AXOD/AXODE (AX4S) UPDATE HANDBOOK

*Updated
October, 2002*

Since the introduction of the Ford AXOD transaxle in model year 1986, there have been many major engineering design changes that have affected many of the parts used in the AXOD transaxle. This version of the AXOD "Update Handbook" begins with the 1986 model year and will explain each change, the parts affected by the change, and any parts interchange problems created by the change. This booklet is an updated version of the original.

Figure 94

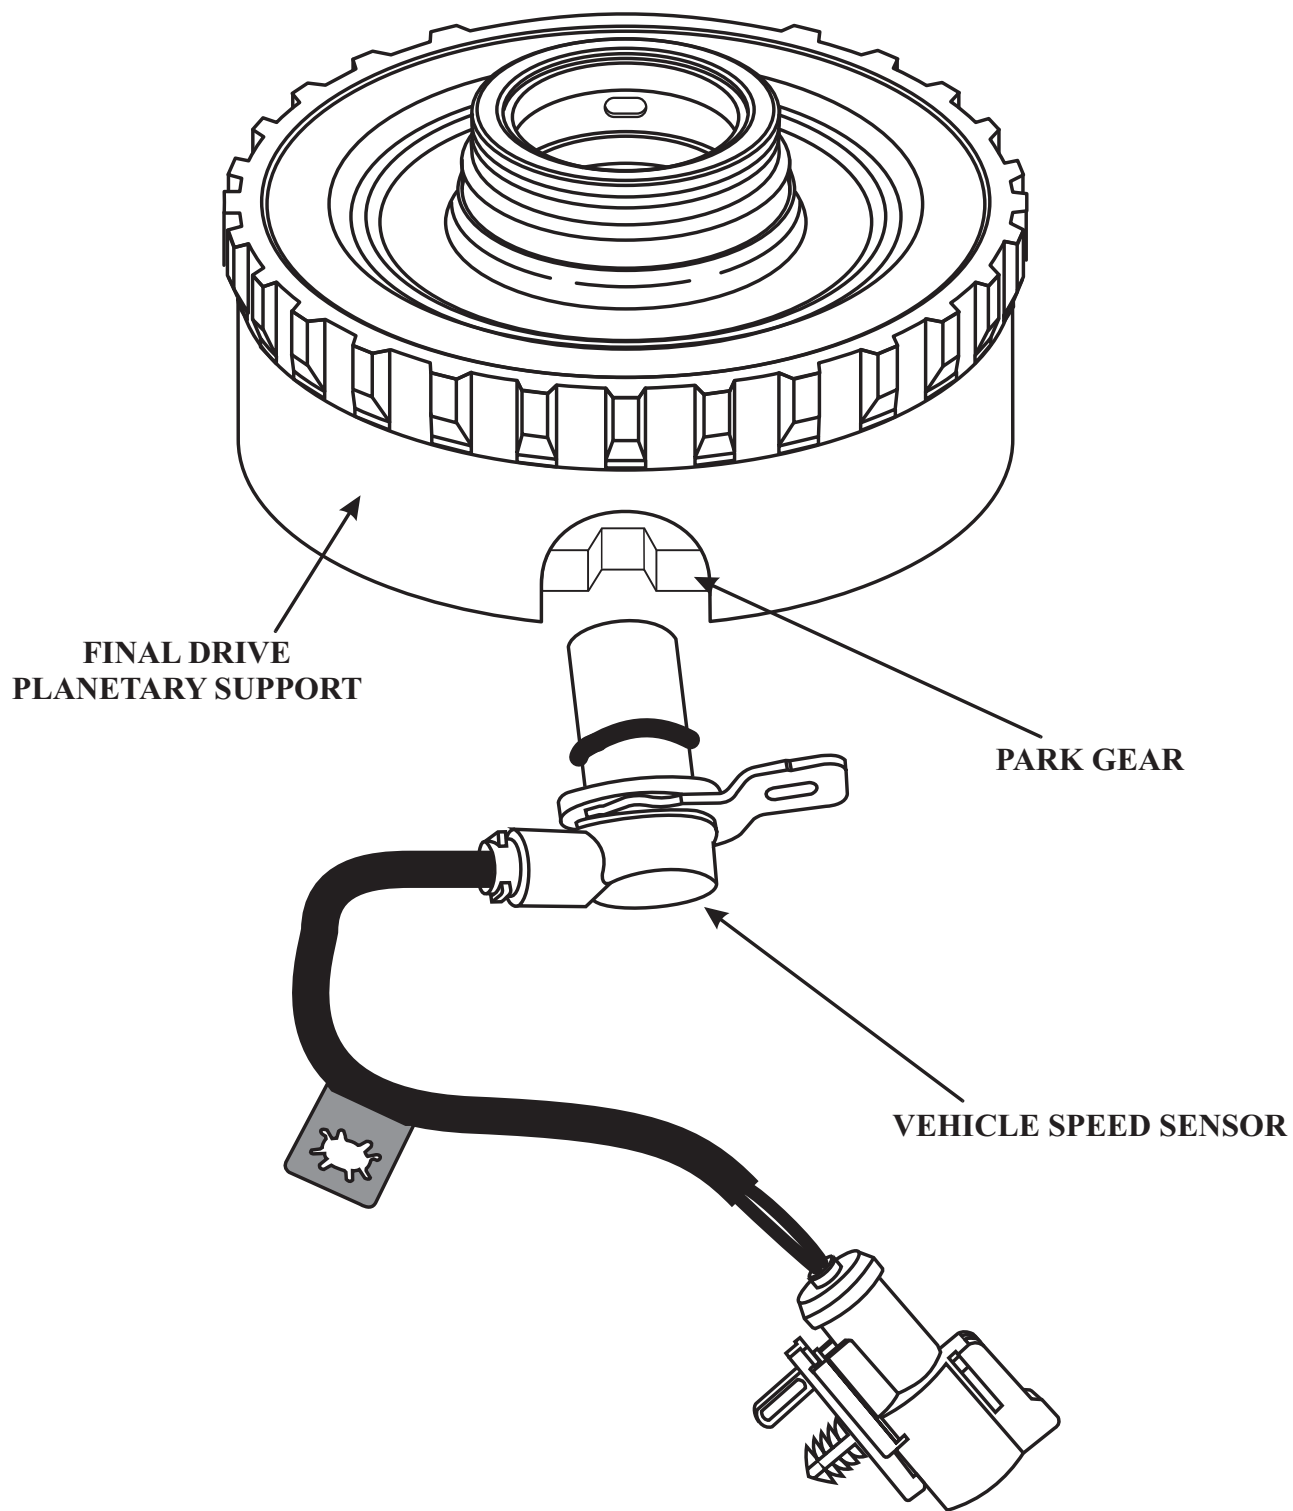
- (1) TRANSAXLE CASE - Changed to accommodate mounting the new design speed sensor so that it is in line with the planetary support and the park gear.
- (2) FINAL DRIVE SUPPORT - Changed to accommodate mounting the new design speed sensor and now has a "cut out" for the speed sensor to look through at the park gear, as shown in Figure 94.

Figure 97

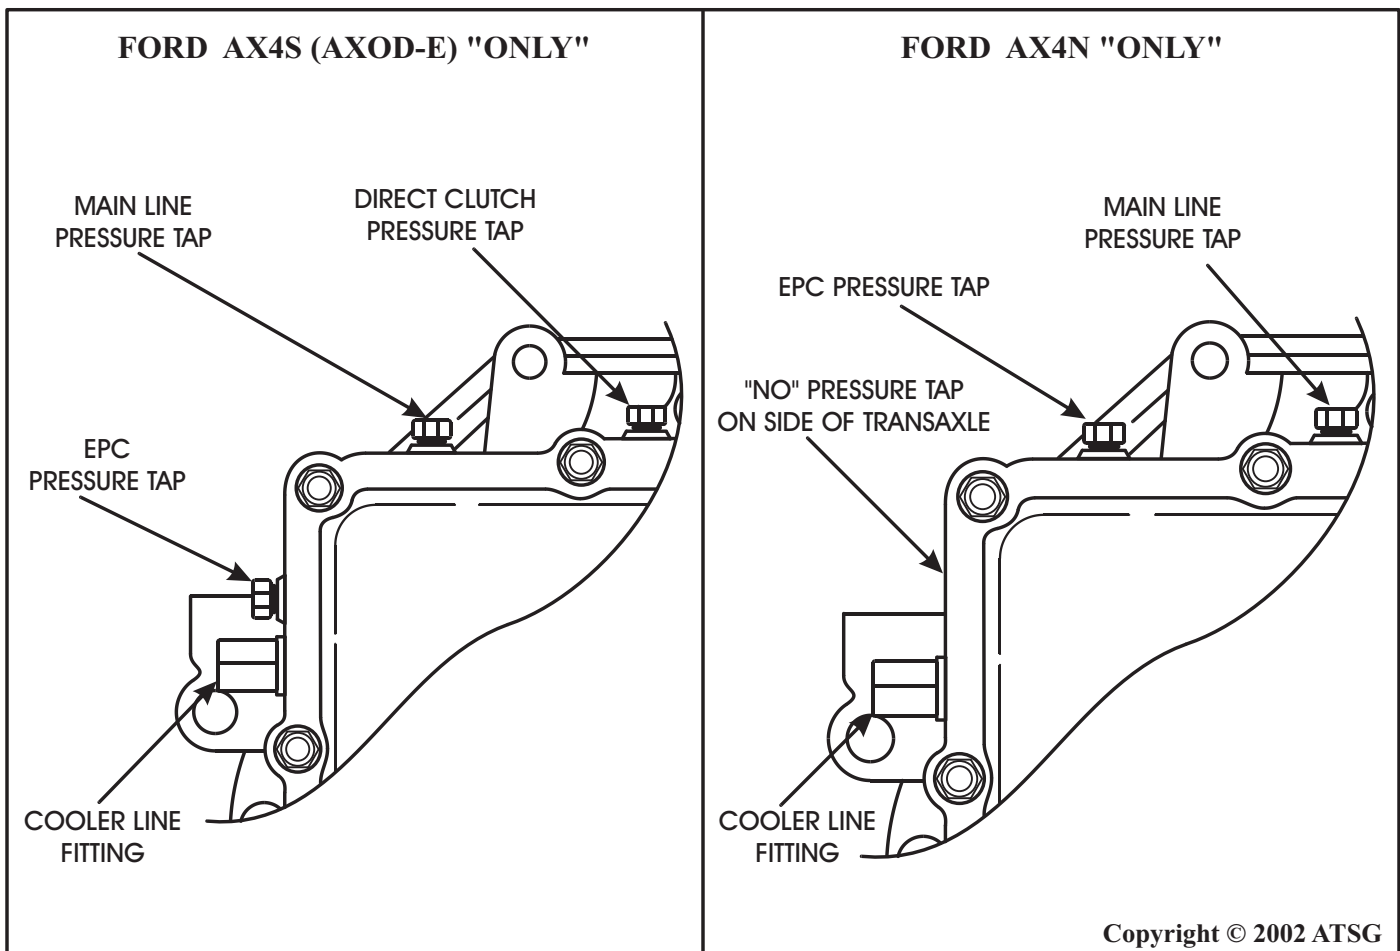
Most technical manuals, including Ford Motor Company manuals, have the pressure tap locations identified wrong. Use this page to correct your manuals at the shop for the correct pressure tap locations.

Refer to Figure 97 for the AX4S (AXOD-E) transaxle pressure tap locations.

Figure 100

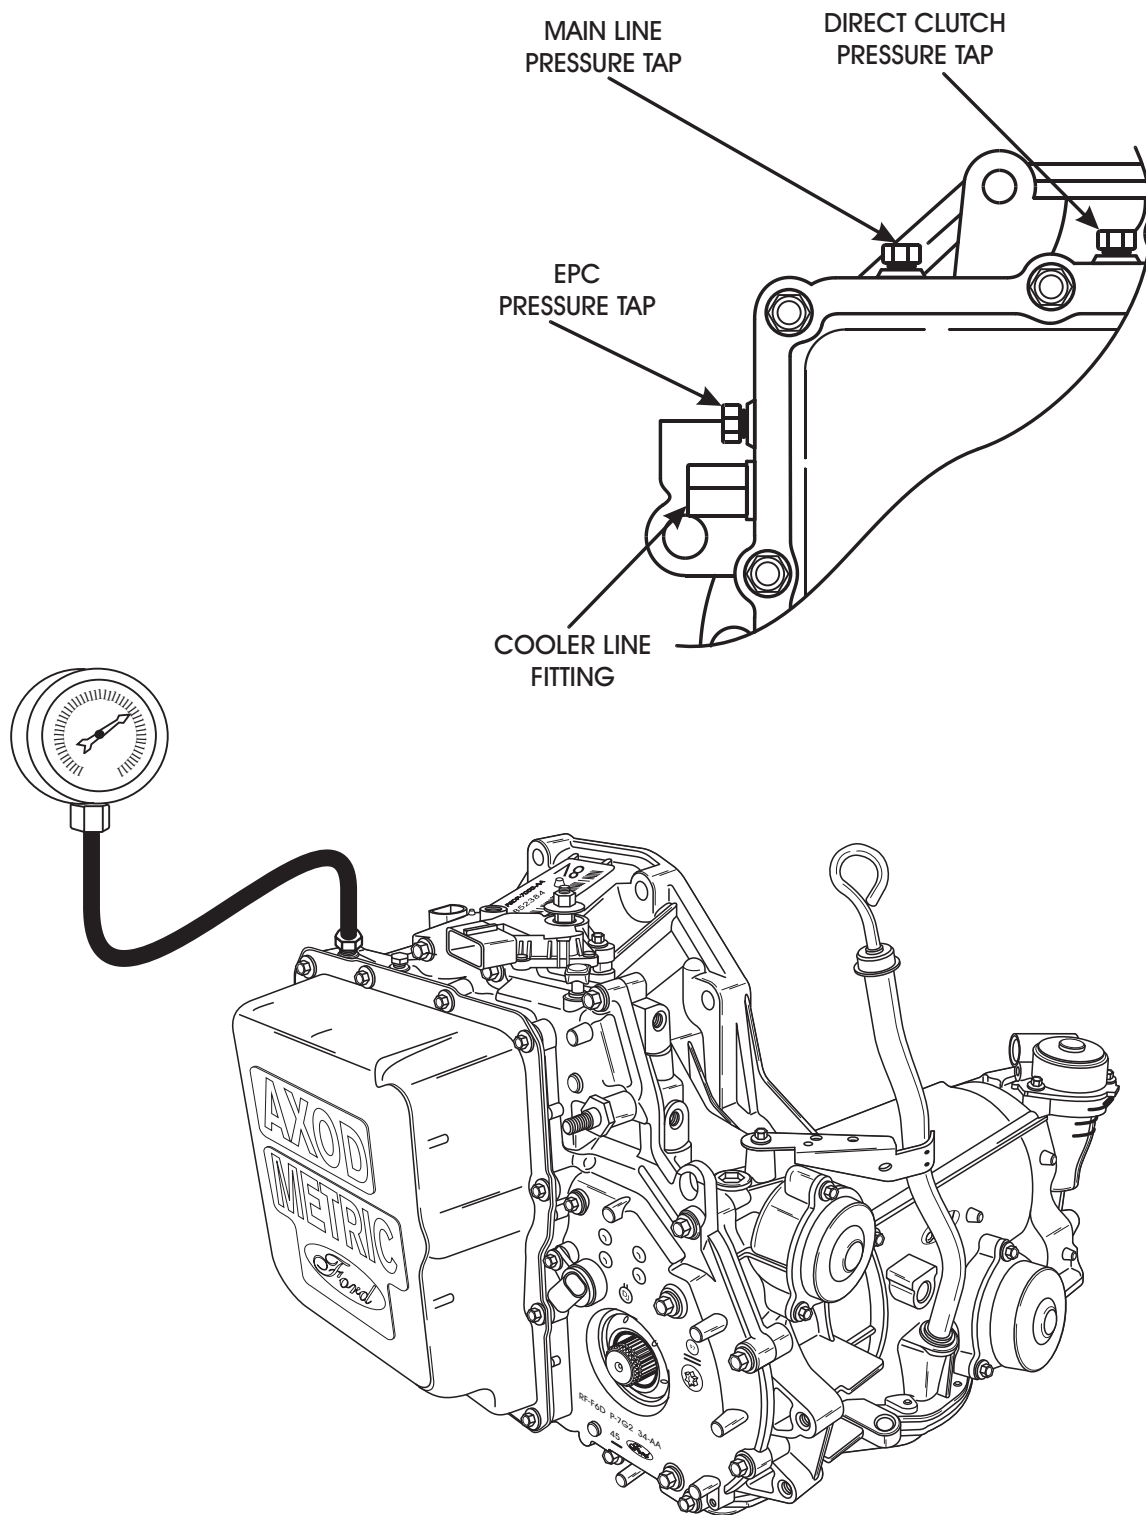
Connect the 0-400 lb. pressure gauge to the mainline pressure tap, as shown in Figure 100. Cut the White wire with the Yellow tracer and hook the DVOM, **in series**, so that current flows **through** the DVOM, as shown in Figure 99. Start the engine and let it warm up until the pressure stabilizes between 48-77 PSI. The amperage reading at idle should be approximately 1 Amp. As the throttle is opened, amperage should begin to drop, and pressure should begin to rise. Refer to the chart in Figure 99.

Figure 101

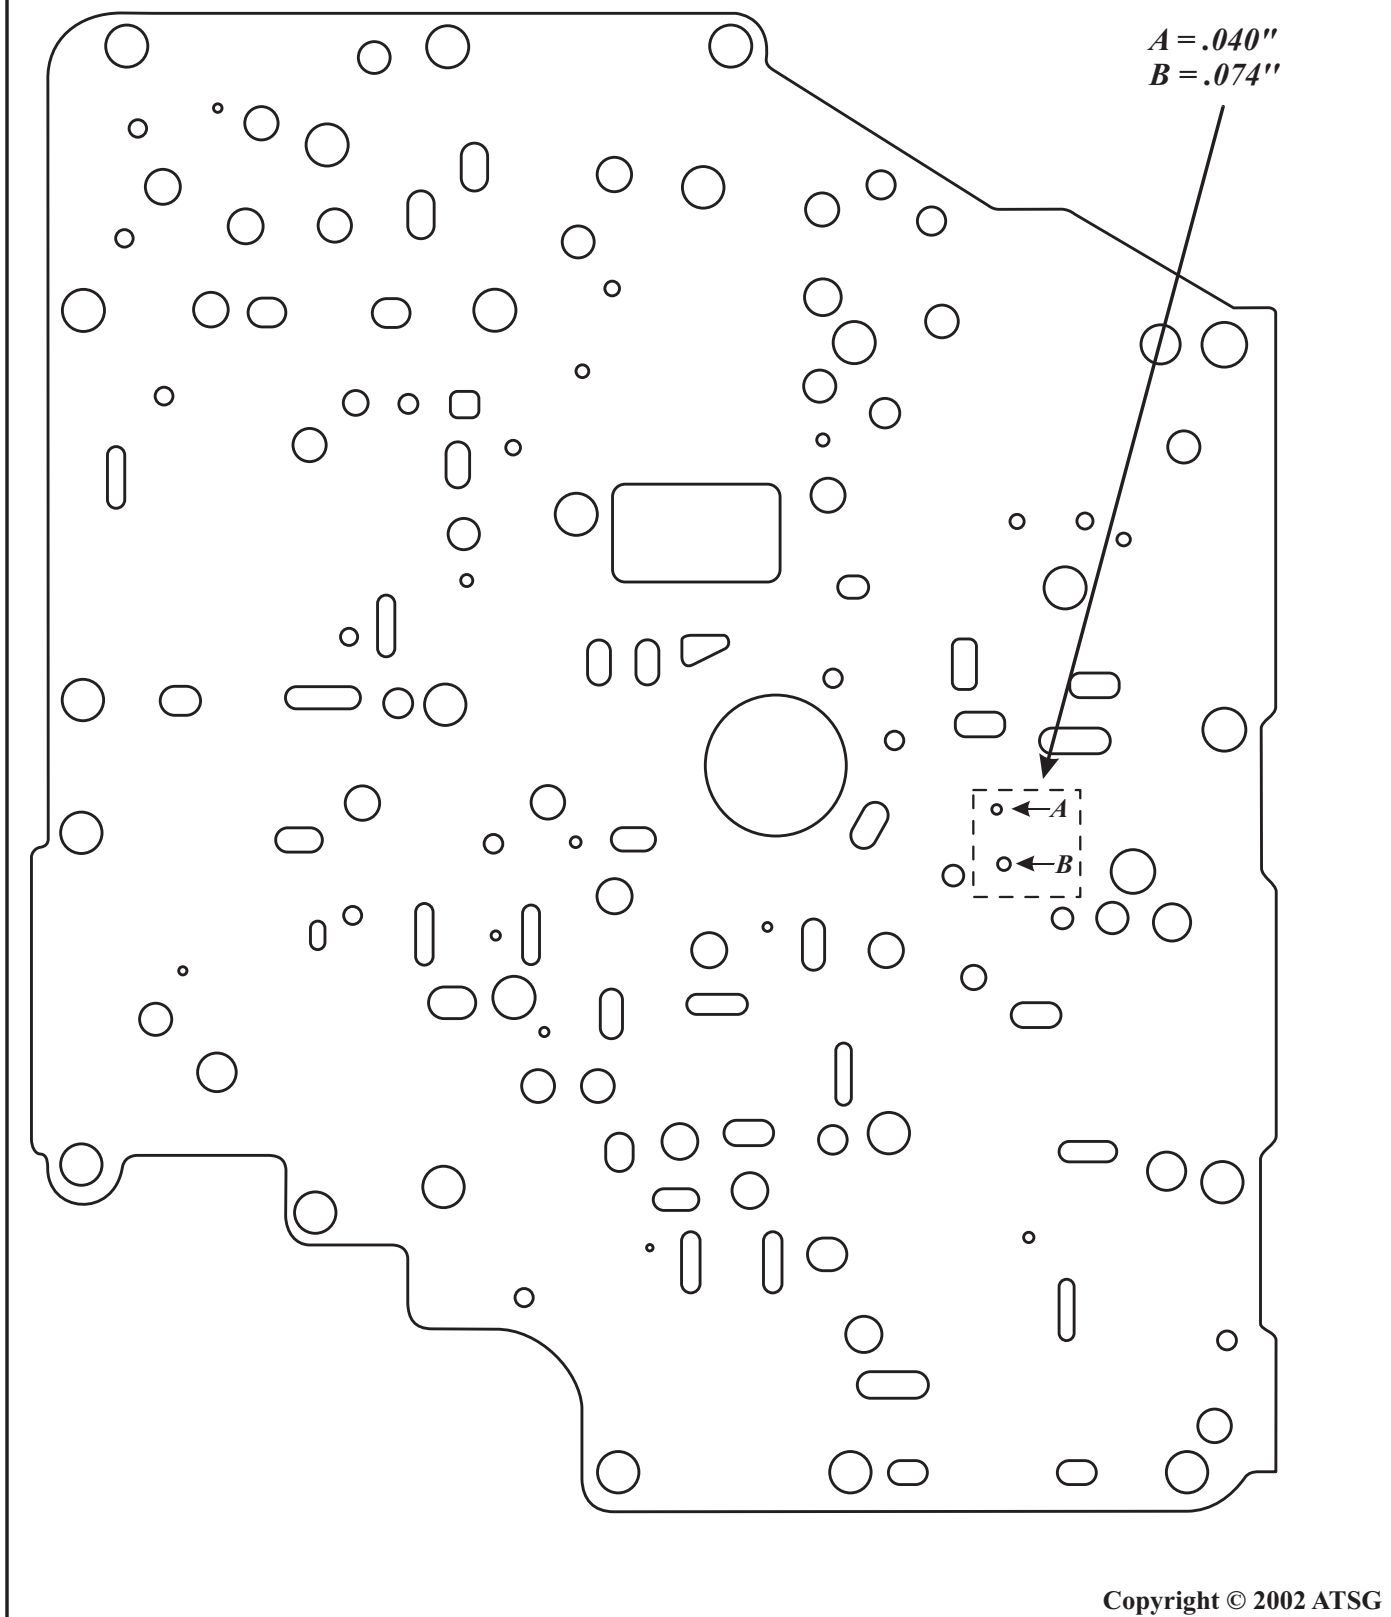
COMPLAINT: Some 1995-Up Ford Windstar Vans may exhibit a harsh 1-2 upshift, either before and/or after overhaul of the transaxle. Some 1995-Up Ford Taurus, Mercury Sable or Lincoln Continental may exhibit a soft or flare on the 1-2 upshift either before or after overhaul.

CAUSE: The cause may be, a valve body spacer plate designed for the Taurus, Sable, Continental passenger car family, has been installed on a Windstar Van, creating a harsh 1-2 upshift. If the Windstar Van valve body spacer plate, is installed on the Taurus, Sable, Continental family of vehicles, the result will be a soft or flared 1-2 upshift. ***Obviously these two spacer plates are different.*** Refer to Figures 101 and 102, using the two holes over the 1-2 capacity modulator valve area, for identification.

CORRECTION: Install the proper valve body spacer plate for the Ford family that you happen to be servicing at this time. Refer to the illustration in Figure 101 to identify the valve body spacer plate for the Windstar Van. Refer to the illustration in Figure 102 to identify the valve body spacer plate for the Taurus, Sable and Continental family.

Figure 103

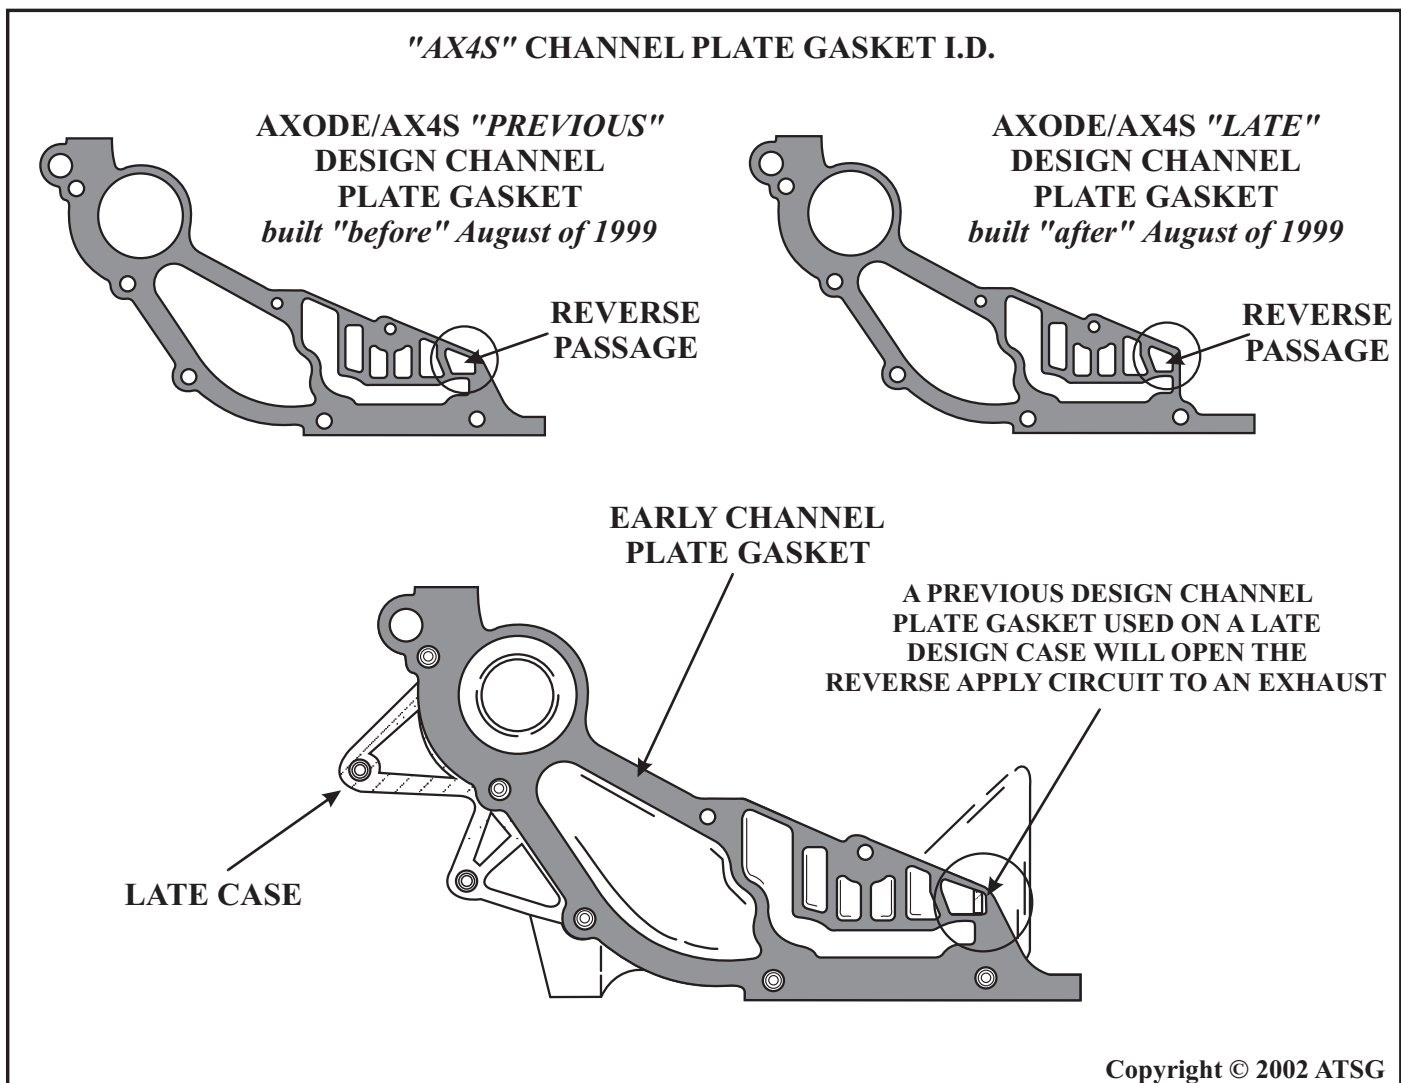
CAUSE: The cause may be, that the *Previous Design* Channel Plate Gasket, was used on a *Late Design* case as shown in Figure 103. When this happens, Reverse apply pressure will be exhausted back into the case because of the gasket hanging over the case casting.

CORRECTION: AX4S-Refer to Figure 103 to identify the correct Channel Plate Gasket for the application of vehicle you are working on.
AX4N-Refer to Figure 104 to identify the correct Channel Plate Gasket for the application of vehicle you are working on.
